AMENDMENT OF SOLICITATION/MODIFICATION OF CONTRACT		BPA NO.	1. CONTRACT ID CODE	PAGE 1	OF PAGES 10
2. AMENDMENT/MODIFICATION NO. A00003		3. EFFECTIVE DATE 09-08-2015	4. REQUISITION/PURCHASE REQ. NO. 675-15-2-6365-0017	5. PROJECT NO. (If applicable) 675-14-853	
6. ISSUED BY Department of Veterans Affairs Orlando VA Medical Center 5201 Raymond Street Orlando FL 32803		CODE	7. ADMINISTERED BY (If other than Item 6) Department of Veterans Affairs Network Contracting Activity 8 (NCO 8) Orlando VA Medical Center 5201 Raymond Street Orlando FL 32803		CODE 00675
8. NAME AND ADDRESS OF CONTRACTOR (No., street, county, State and ZIP Code) To all Offerors/Bidders			(X)	9A. AMENDMENT OF SOLICITATION NO. VA248-15-R-1702	
			X	9B. DATED (SEE ITEM 11) 08-10-2015	
				10A. MODIFICATION OF CONTRACT/ORDER NO.	
				10B. DATED (SEE ITEM 13)	
CODE		FACILITY CODE

- 1) Provide additional drawing ;
- 2) Provide responses to Request for Information (RFI), and
- 3) Provide a copy of the 09/02/2015 site visit sign-in sheet .

Request for Information (RFI) Tracking Log**Solicitation: VA-248-15-R-1702****Project: 675-14-853****Title: Paint All Common Interior Areas-****Viera RFI Tracking Log_RFI# 1-25****9/8/

Attachment 1 _B Wing 9- 8- 15

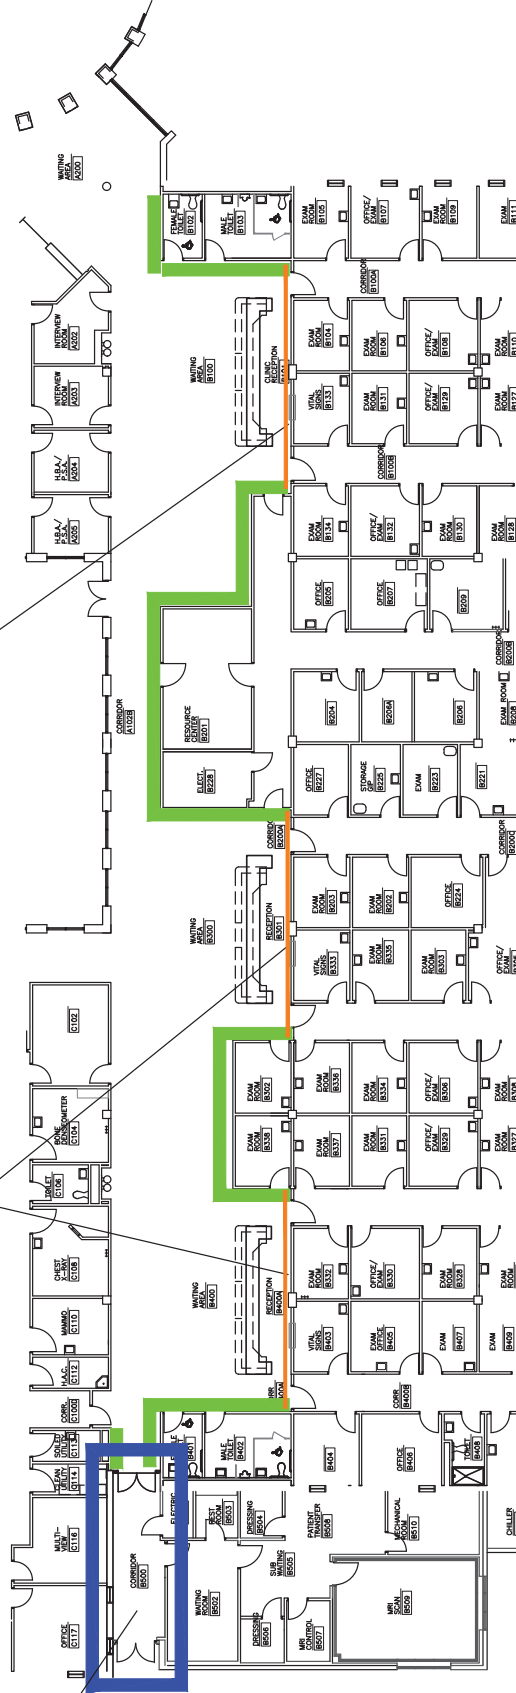
Response	Try your best to match the existing texture on the walls behind the handrails.		
24.	4. Reference Addendum #2 RFI #14 response states "...removing and replacing all fixtures, if possible, and or fixture covers." Please confirm the response was meant to state remove and reinstall.		
Response	This comment is for all light fixtures. Contractor shall remove any portion of the light cover and re-install all light covers.		
25.	Is the end of portion of the B Wing hallway between the two doors adjacent to the MRI included in this contract?		
Response	No. The portion of the hallway between the two doors adjacent to the MRI is not included in this contract. The contractor is required to paint the entire door jamb of the interior door shown within the blue rectangle. Please see attached B Wing drawing dated 9 8 15.

GREEN COLOR DENOTES EXISTING HANDRAILS, GUARDRAILS & CORNER GUARDS TO REMAIN

PROPOSED ACCENT WALLS

THIS PORTION OF THE B WING HALLWAY, BETWEEN THE TWO DOORS, IS NOT IN CONTRACT
